PEACH BOTTOM ATOMIC POWER STATION, UNIT NO. 2

AMENDMENT TO FACILITY OPERATING LICENSE

Amendment No. 40  
License No. DPR-44

ATTACHMENT TO LICENSE AMENDMENT NO. 40  
TO THE TECHNICAL SPECIFICATIONS  
FACILITY OPERATING LICENSE NO. DPR-44  
DOCKET NO. 50-277

Figure 3.5.1.A

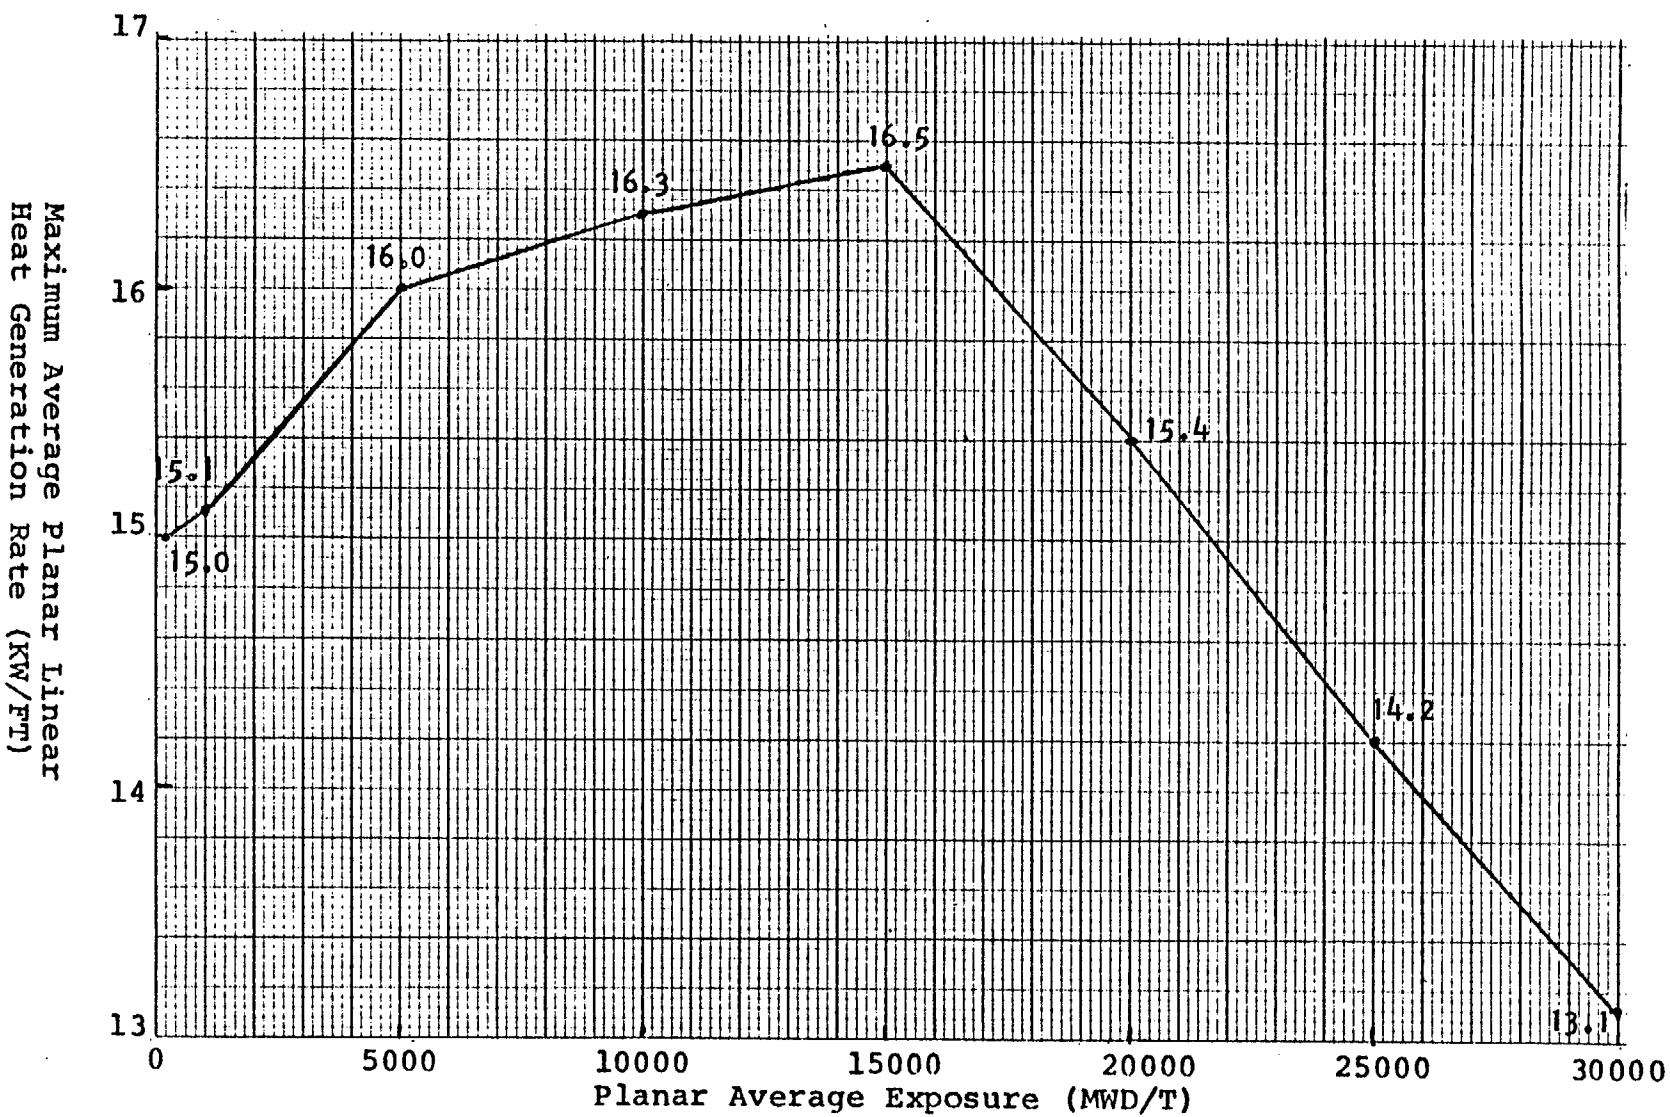
During power operation, the APLHGR for each type of fuel as a function of average planar exposure shall not exceed the limiting value shown in Figure 3.5.1.A, B, C, D, & F, as applicable. If at any time during operation it is determined by normal surveillance that the limiting value of APLHGR is being exceeded, action shall be initiated within one (1) hour to restore APLHGR to within prescribed limits. If the APLHGR is not returned to within prescribed limits within five (5) hours reactor power shall be decreased at a rate which would bring the reactor to the cold shutdown condition within 36 hours unless APLHGR is returned to within limits during this period. Surveillance and corresponding action shall continue until reactor operation is with the prescribed limits.

The calculational procedure used to establish the APLHGR shown on Figures 3.5.1.A, B, C, D, and F is based on a loss-of-coolant accident analysis. The analysis was performed using General Electric (GE) calculational models which are consistent with the requirements of Appendix K to 10 CFR Part 50. A complete discussion of each code employed in the analysis is presented in Reference 4. Input and model changes in the Peach Bottom loss-of-coolant analysis which are different from the previous analyses performed with Reference 4 are described in detail in Reference 8. These changes to the analysis include: (1) consideration of the counter current flow limiting (CCFL) effect, (2) corrected code inputs, and (3) the effect of drilling alternate flow paths in the bundle lower tie plate.

We have reviewed the corrected analyses submitted in Reference 3, and the resulting Technical Specification changes submitted in Reference 4. We conclude that the PBAPS 2 will be in conformance with all requirements of 10 CFR 50.46 and Appendix K to 10 CFR 50.46 when: 1) it is operated in accordance with the "MAPLHGR VERSUS AVERAGE PLANAR EXPOSURE" values given in Figures 3.5.1.A, 3.5.1.B, 3.5.1.C, 3.5.1.D, and 3.5.1.F of Reference 4; and 2) when it is operated at a Minimum Critical Power Ratio (MCPR) equal to or greater than 1.20 (more restrictive MCPR limits are currently required for reasons not connected with the Loss-of-Coolant Accident).

We therefore conclude, for the reasons stated above, that the most limiting break is the largest discharge line break for PBAPS 2. That break was used to generate the above referenced MAPLHGR limits, which we therefore find acceptable as stated previously.
